SUBDIVISION REVIEW SHEET

CASE NO.: C8-2018-0171.2A.SH

SUBDIVISION NAME: Goodnight Ranch Phase 2 East Section 2 - Final Plat

CITY OF AUSTIN –DEVELOPMENT SERVICES DEPARTMENT SUBDIVISION APPLICATION – MASTER COMMENT REPORT

SHEET 1 OF 5

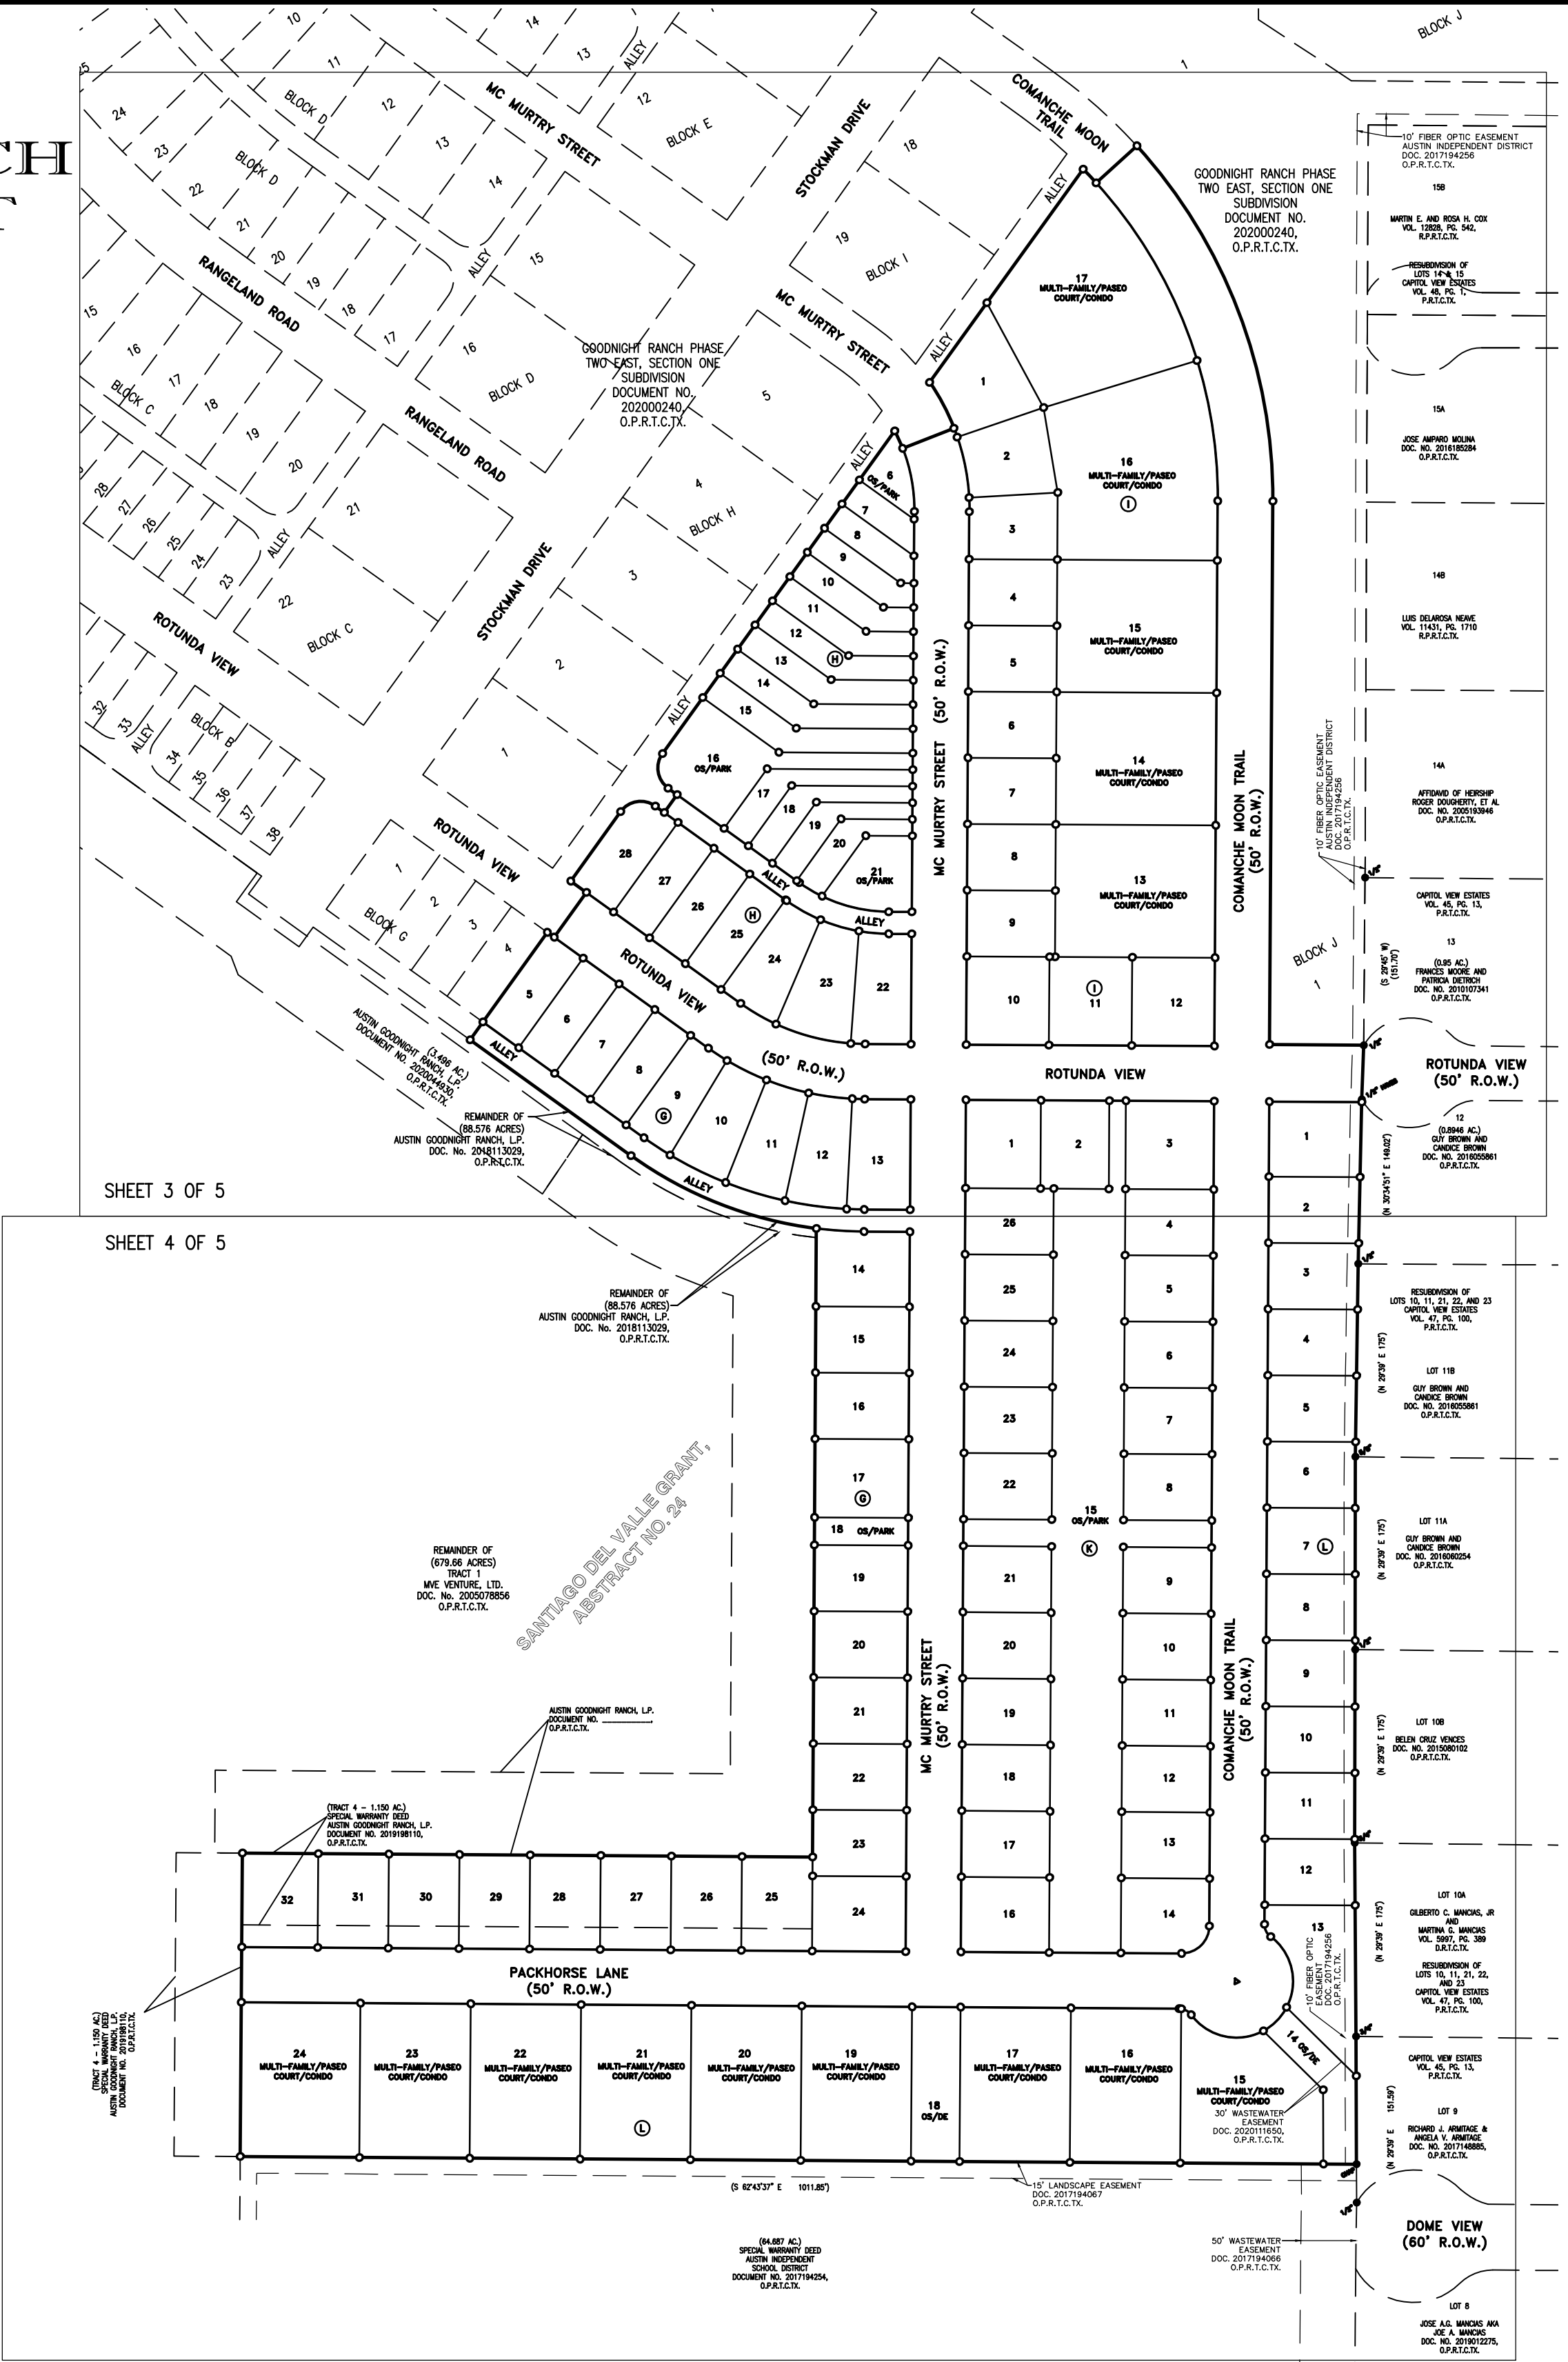
EV 1 Remove the specific reference to Land Development Code Section 25-8-211 shown in plat note number 28 regarding the requirement for water quality controls. A subdivision final plat note should only reference the Land Development Code in general. [[LDC 25-1, Article 4]

AW1. Per Utility Criteria Manual Section 2, §25-4, and the Uniform Plumbing Code:
Replace note 1 with the following:

Replace note 2 with the following:

Replace note 22 with the following:

NO LOT SHALL BE OCCUPIED UNTIL THE STRUCTURE IS CONNECTED TO THE CITY OF AUSTIN WATER AND WASTEWATER UTILITY SYSTEM.

THE WATER AND WASTEWATER UTILITY SYSTEM SERVING THIS SUBDIVISION MUST BE IN ACCORDANCE WITH THE CITY OF AUSTIN UTILITY DESIGN CRITERIA. THE WATER AND WASTEWATER UTILITY PLAN MUST BE REVIEWED AND APPROVED BY AUSTIN WATER. ALL WATER AND WASTEWATER CONSTRUCTION MUST BE INSPECTED BY THE CITY OF AUSTIN. THE LANDOWNER MUST PAY THE CITY INSPECTION FEE WITH THE UTILITY CONSTRUCTION.

THE WATER AND/OR WASTEWATER EASEMENTS INDICATED ON THIS PLAT ARE FOR THE PURPOSE OF CONSTRUCTION, OPERATION, MAINTENANCE, REPAIR, REPLACEMENT, UPGRADE, DECOMMISSIONING AND REMOVAL OF WATER AND/OR WASTEWATER FACILITIES AND APPURTENANCES. NO OBJECTS, INCLUDING BUT NOT LIMITED TO, BUILDINGS, RETAINING WALLS, TREES OR OTHER STRUCTURES ARE PERMITTED IN WATER AND/OR WASTEWATER EASEMENTS EXCEPT AS APPROVED BY AUSTIN WATER.
